TOPICS DISCUSSED Aug 26-27 in EXPERT MP00081
MAJM REV BY
 FRED NATICH

DESIGN BRIEF

PROJECT NO. _____ SHORT TITLE Imperial Metals

DESIGN SUBJECT Mt. Polley Mine

☒ - LOWER BASIN LINER
(1st Lift Placed)

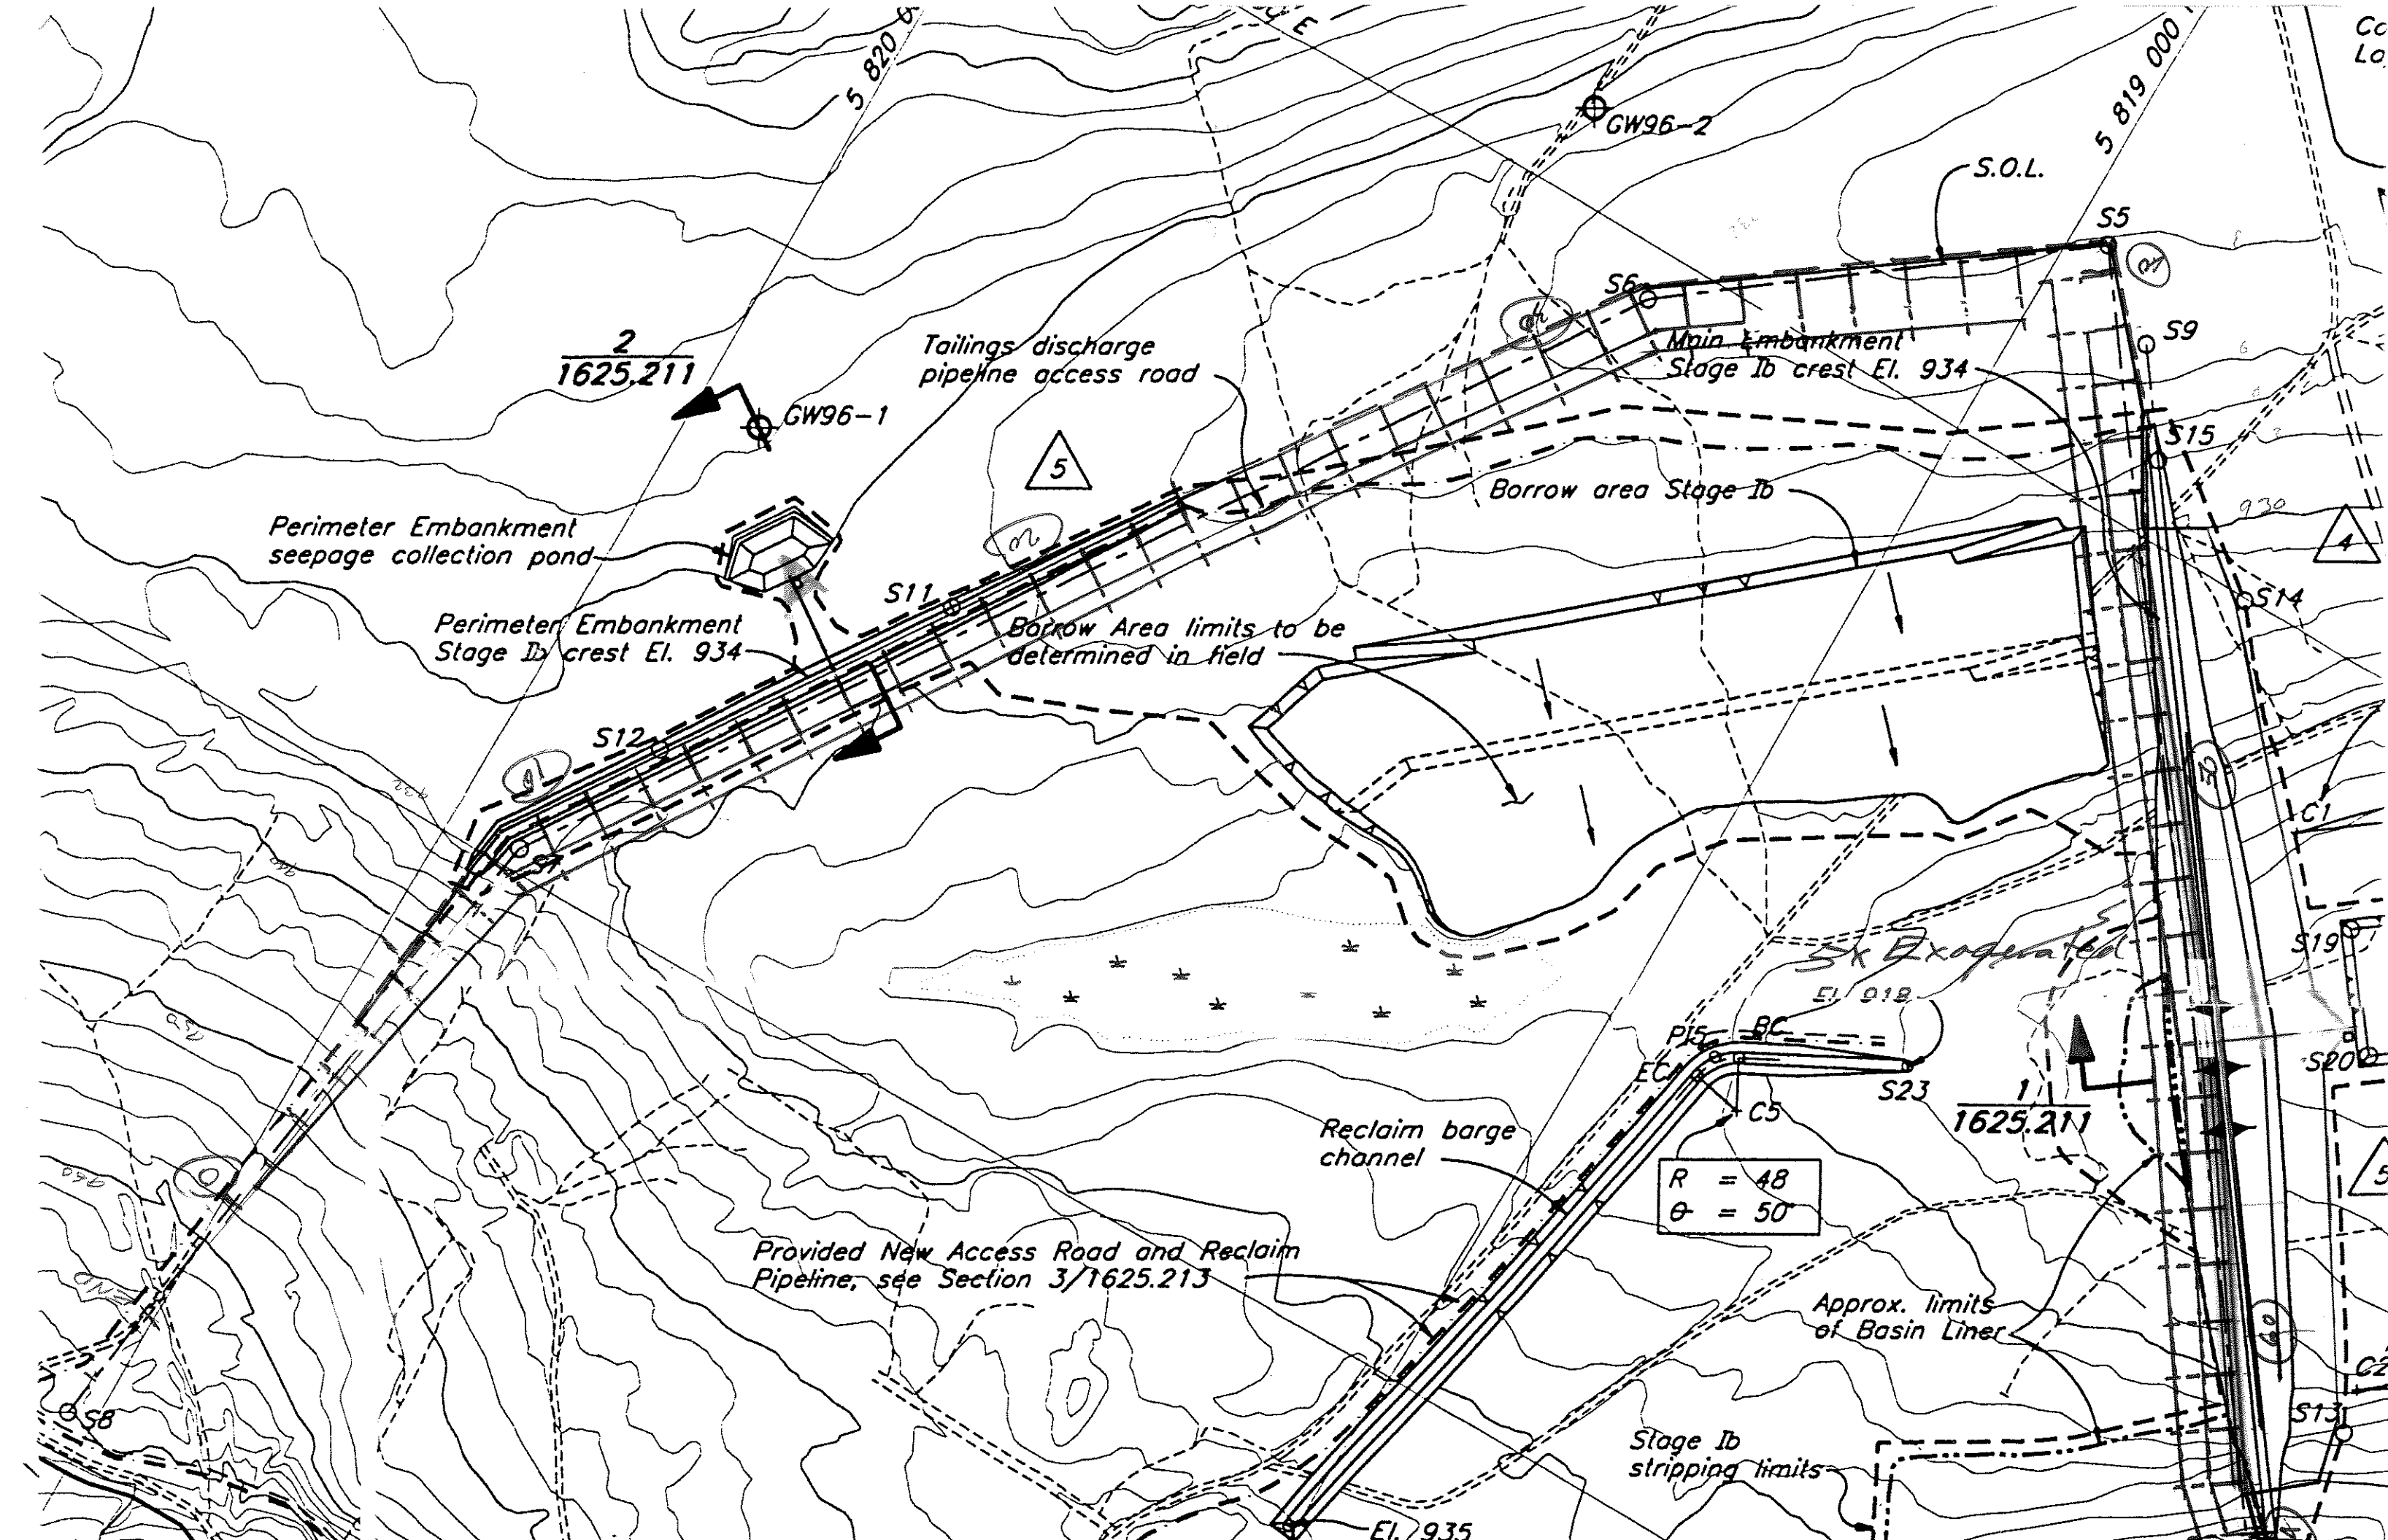
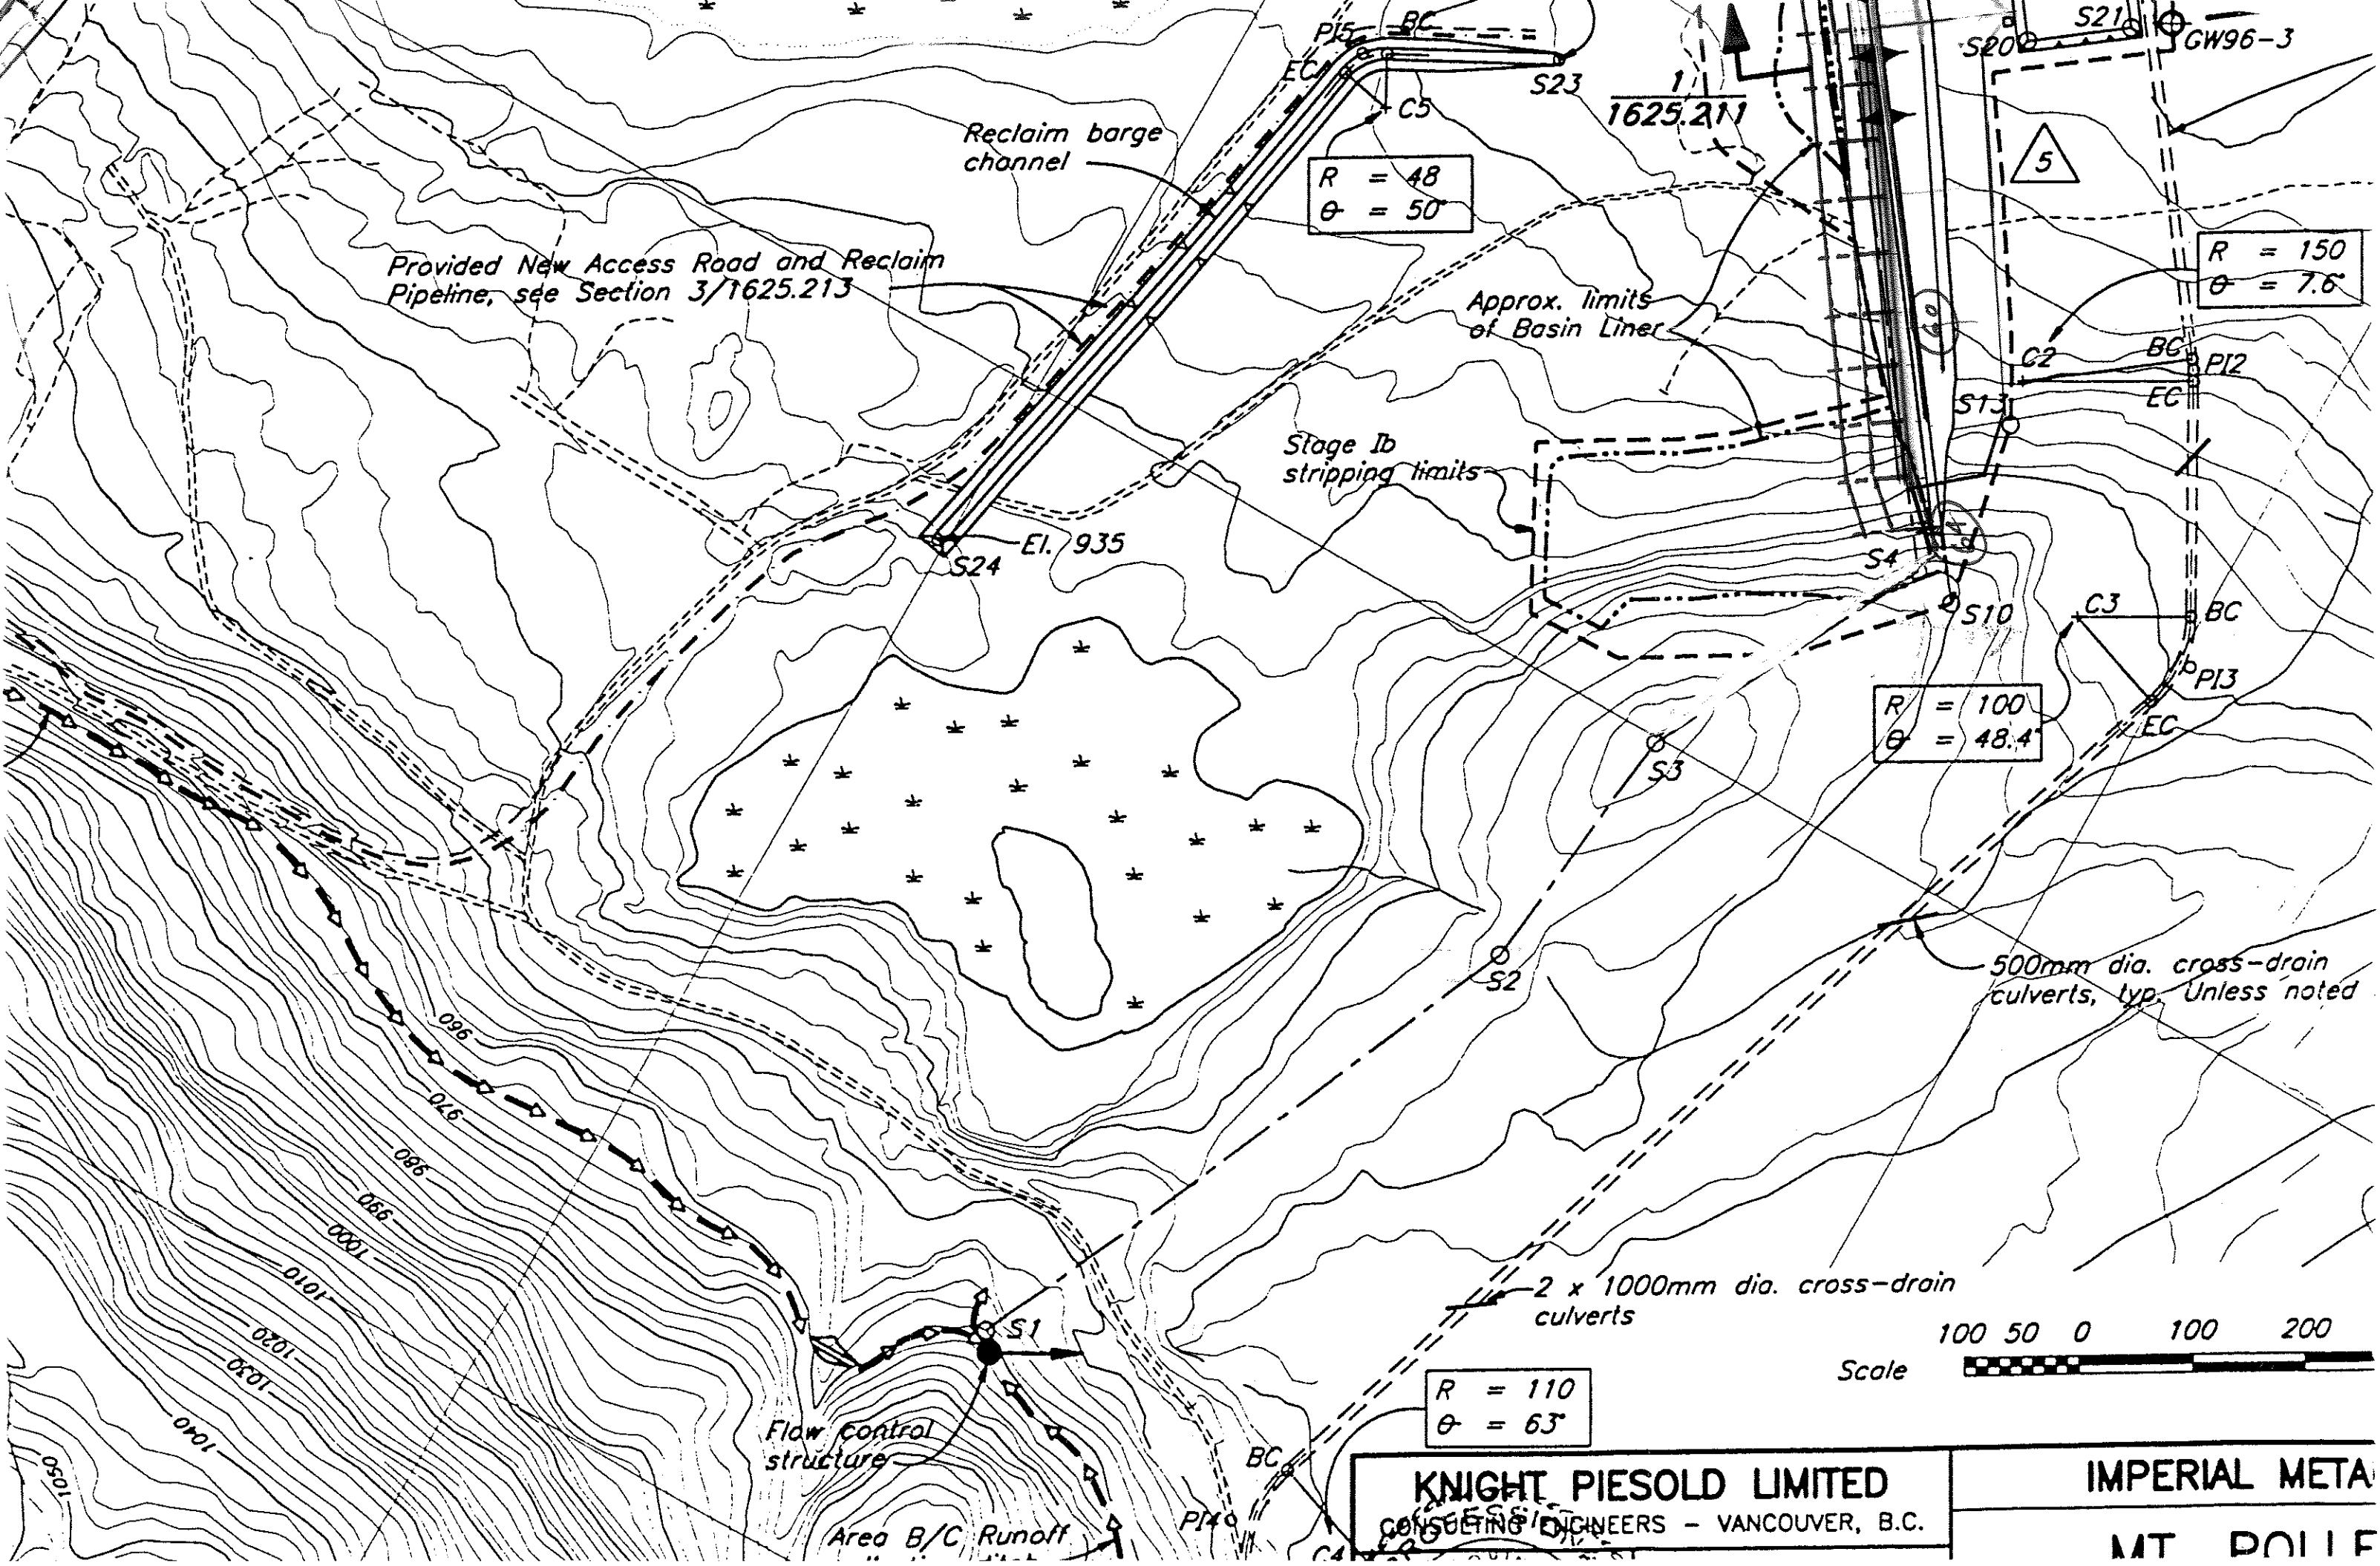
ORIGINAL
NOT NEEDED → 13300 m²
NEEDED → 36500 m²
TOTAL (CONTRACT) → 50,000 m²
Additional (To Date) 13,300 m²
Remaining
